KTN - FFY08 AREAWIDE PAVING AC-NH-0003(131) ~ 67791

TONGASS AVENUE FIRE STATION TO HOSPITAL

N. POINT HIGGINS ROAD

As-Built Plans

**PROPOSED TYPICAL SECTION
HOADLEY CREEK BRIDGE**

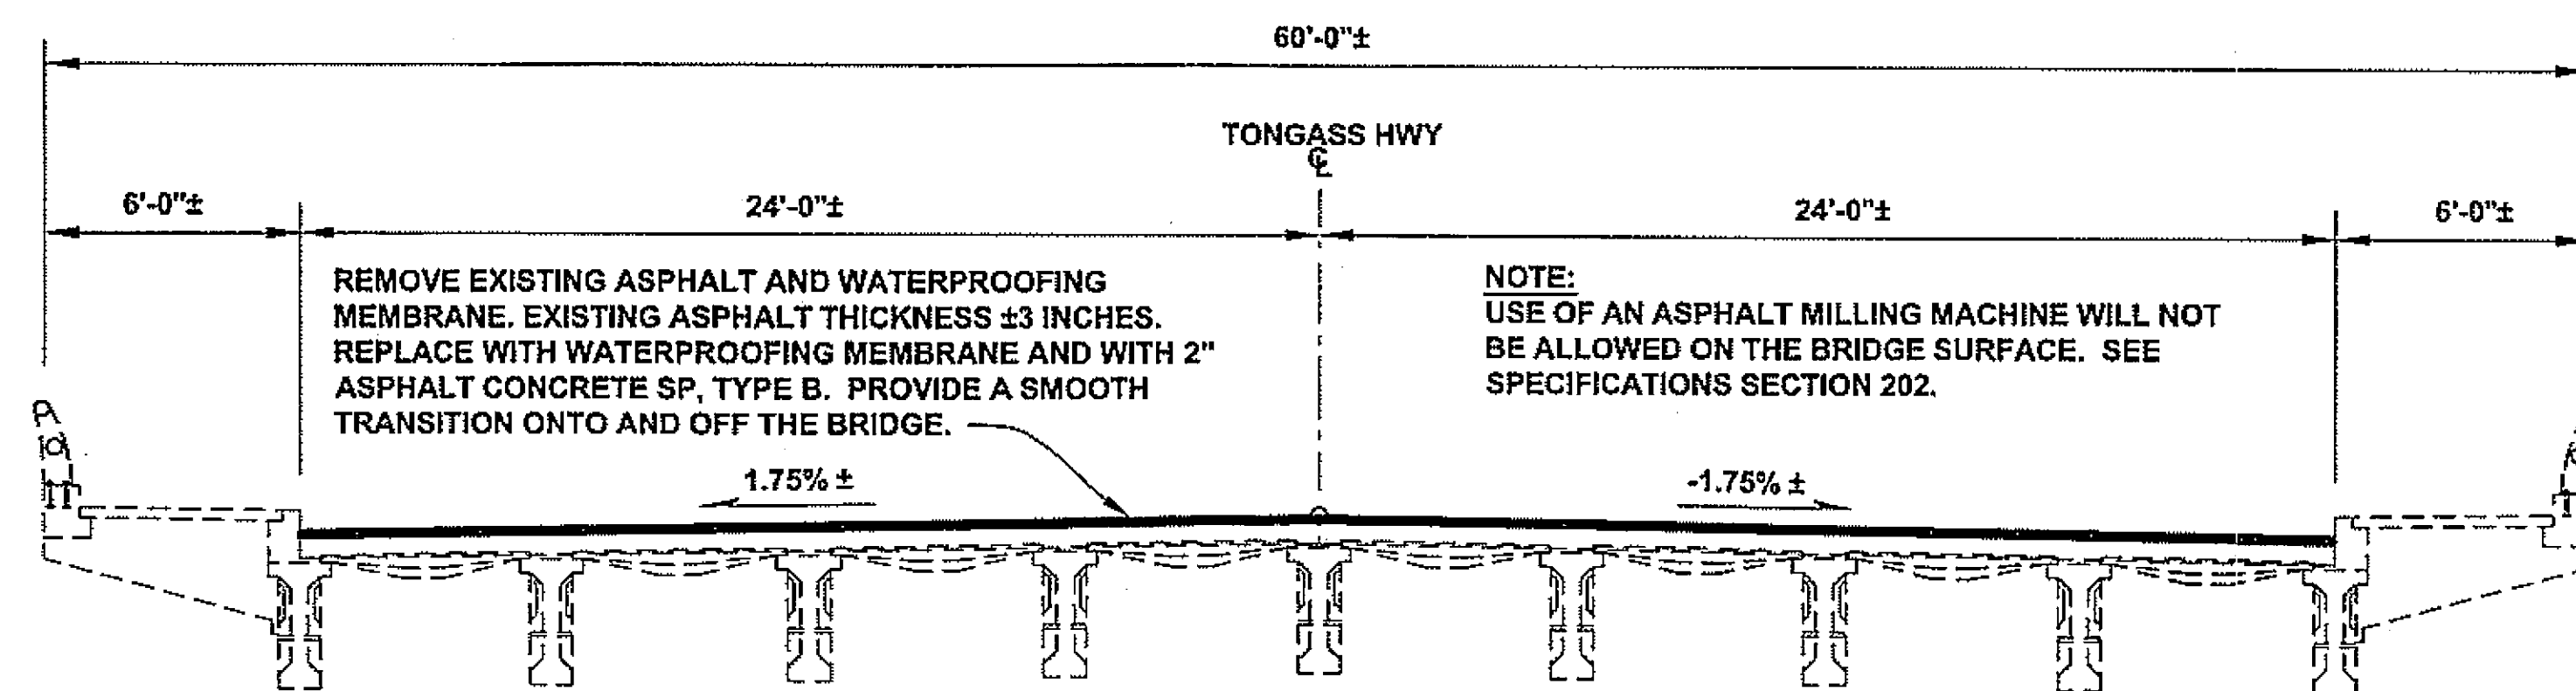
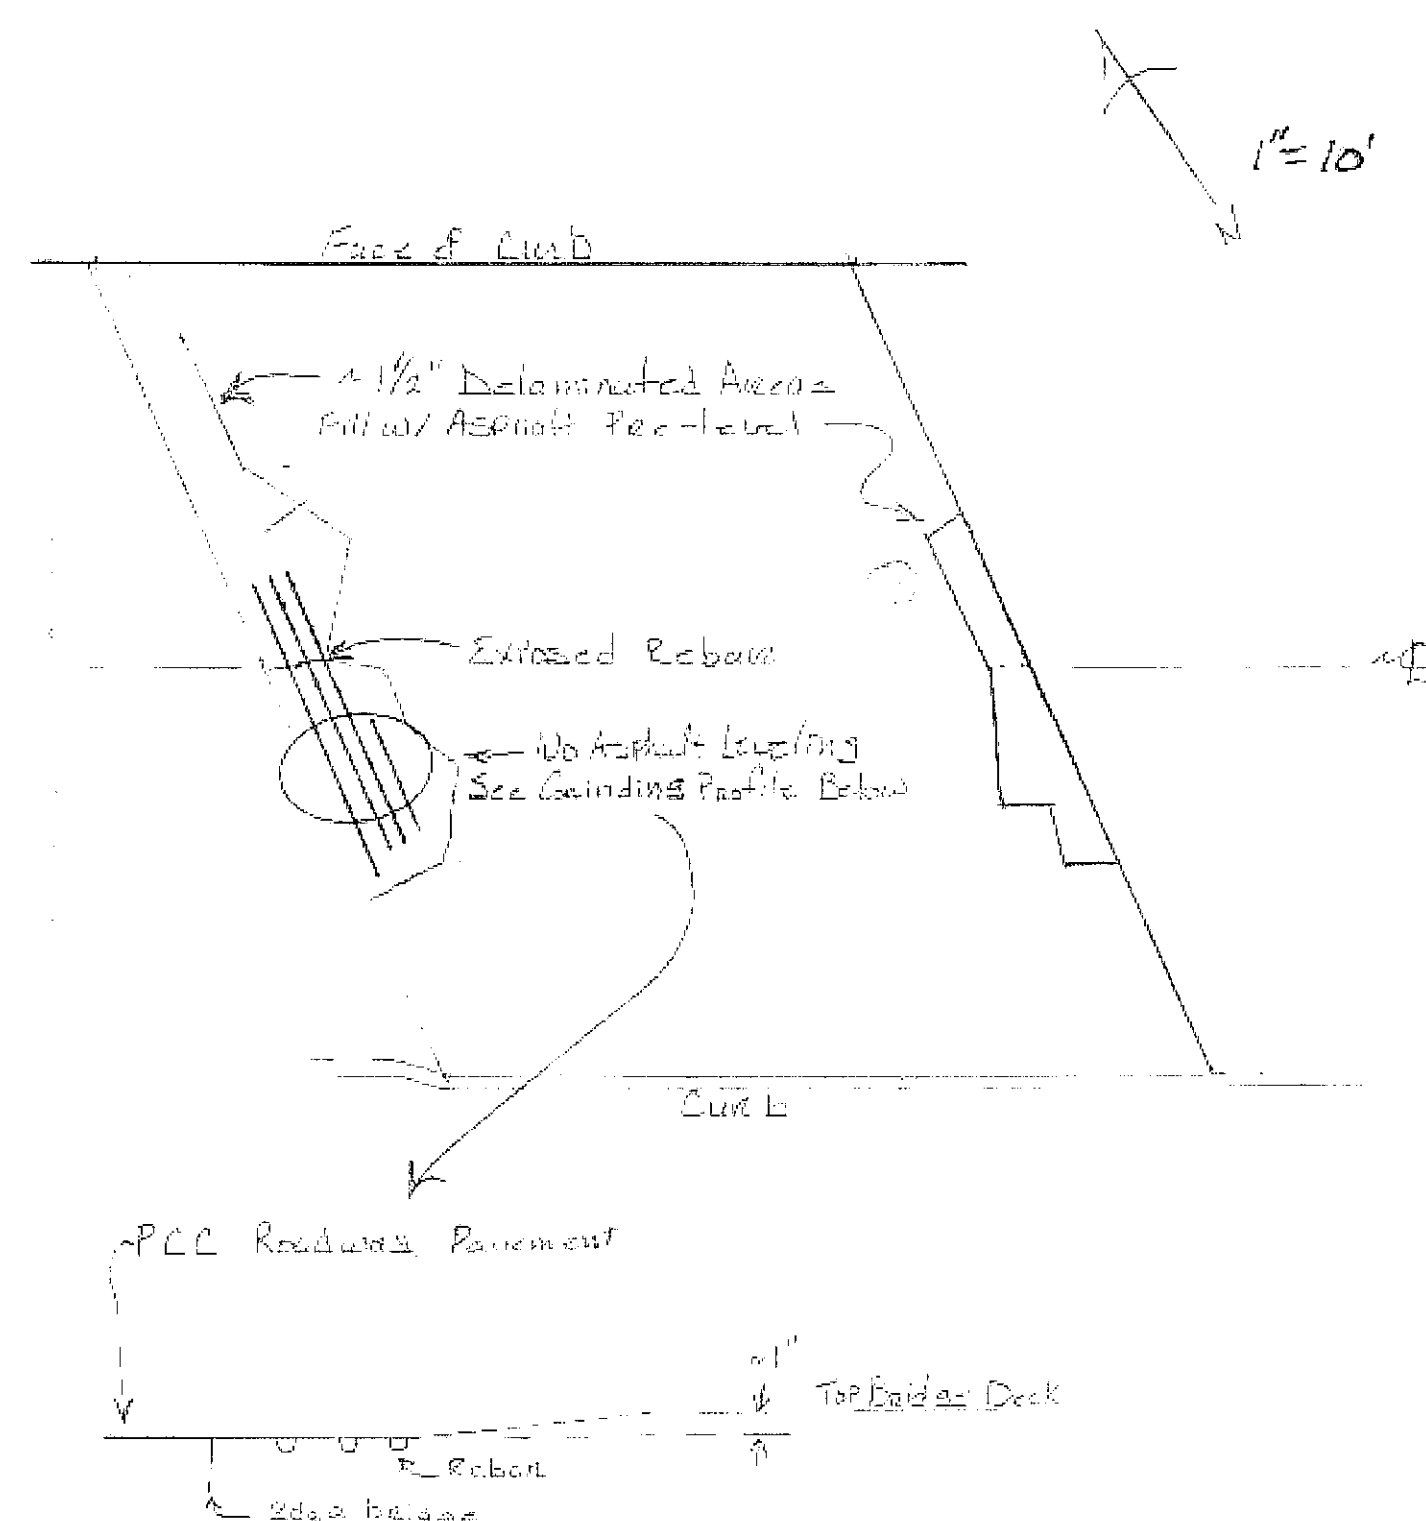
The bridge surface was delaminated in several areas and an asphalt leveling course was used prior to membrane application, (see drawing). These delaminated areas were adhered to the asphalt and pulled up when the pavement was removed. The remaining surface showed evidence of being milled during a past project which left the typical rough surface and exposed the rebar mat in one area. Soundings with a hammer indicated several other areas of potential delamination.

SANITARY SEWER CLEANOUT DETAIL

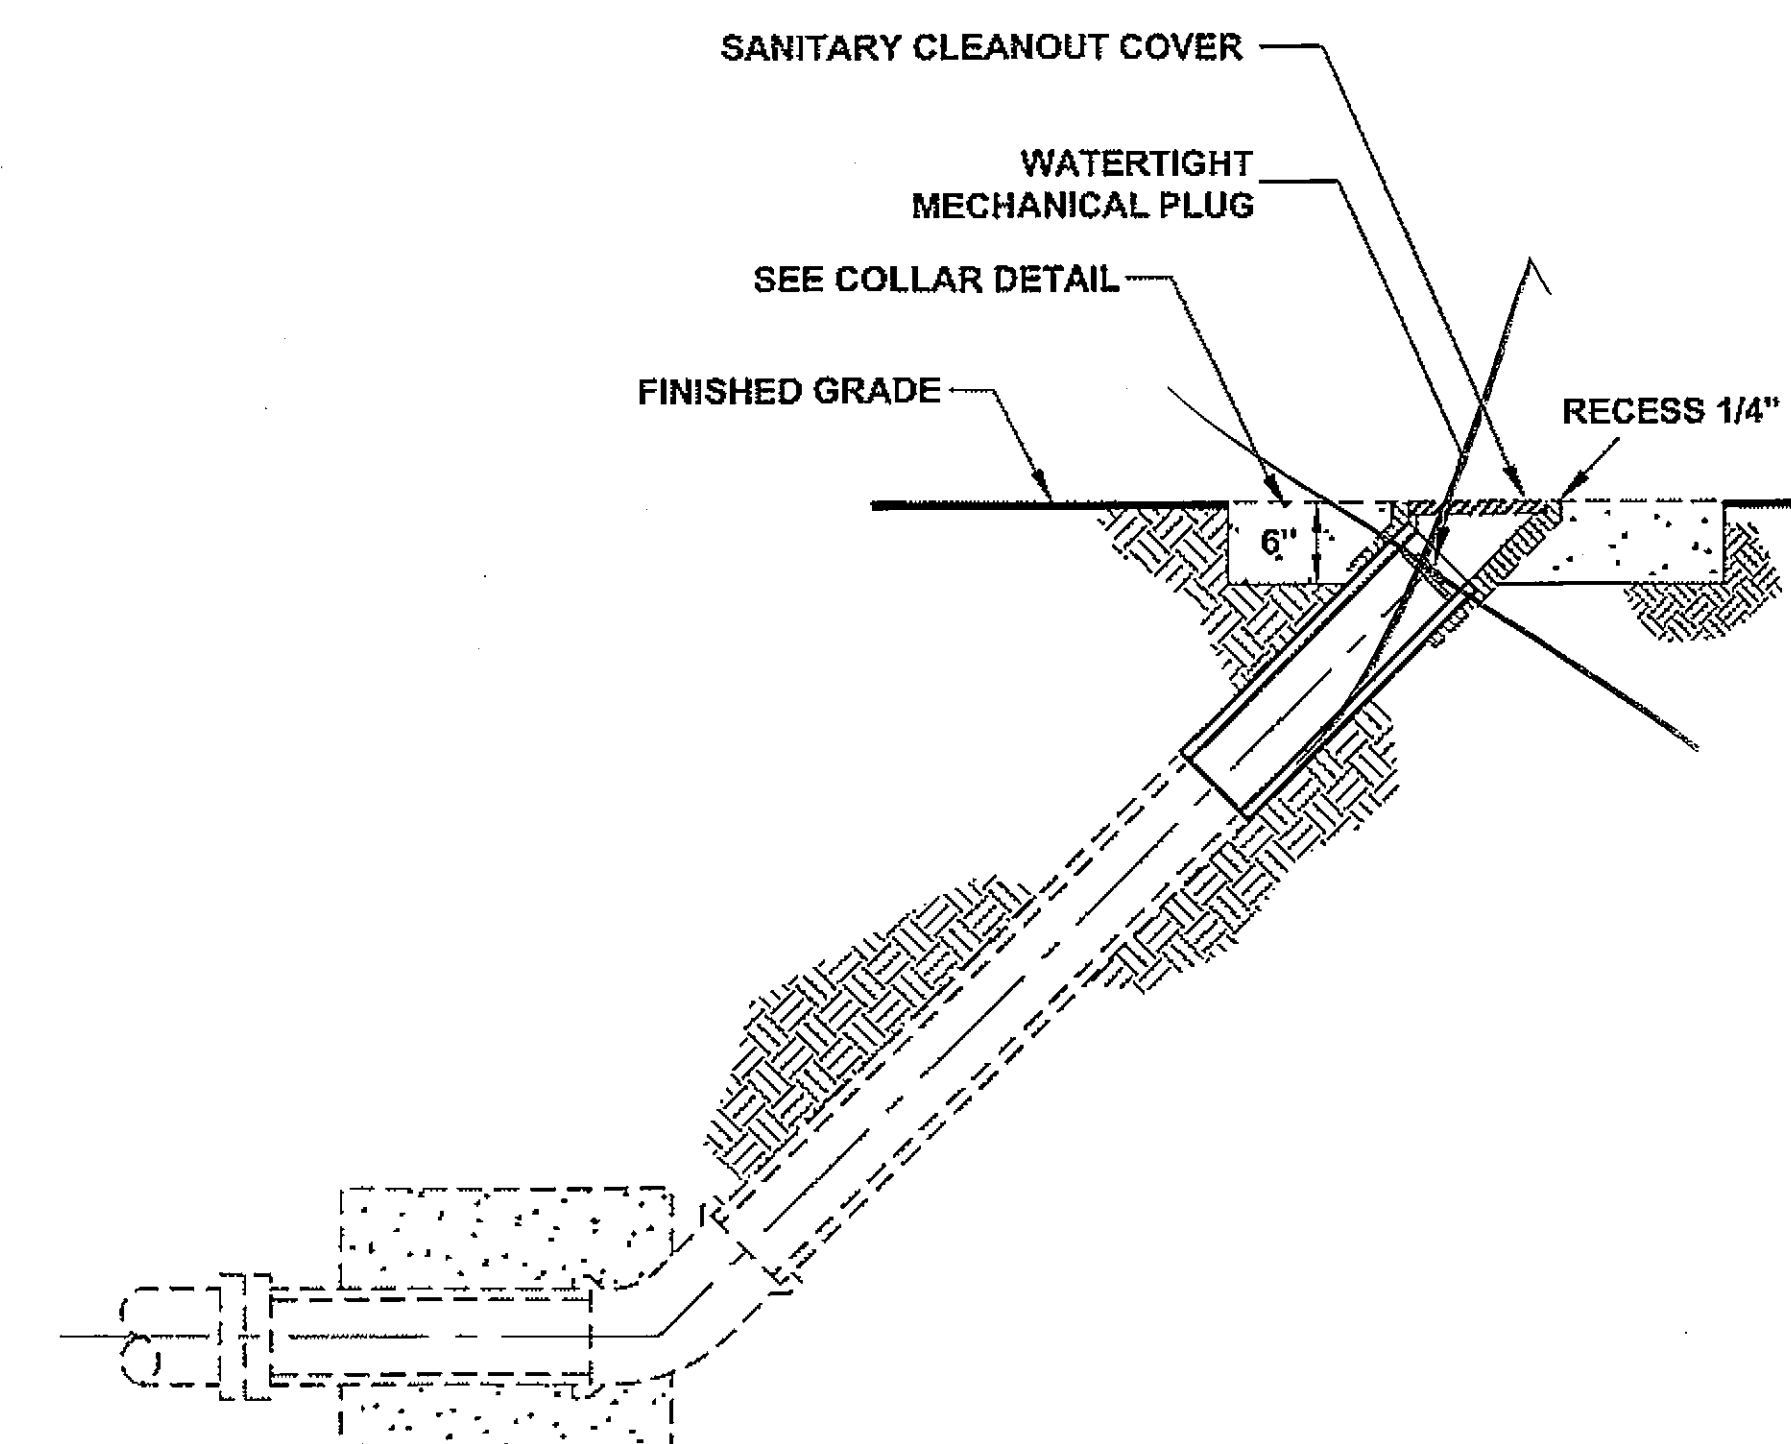
Deleted per City of KTN.
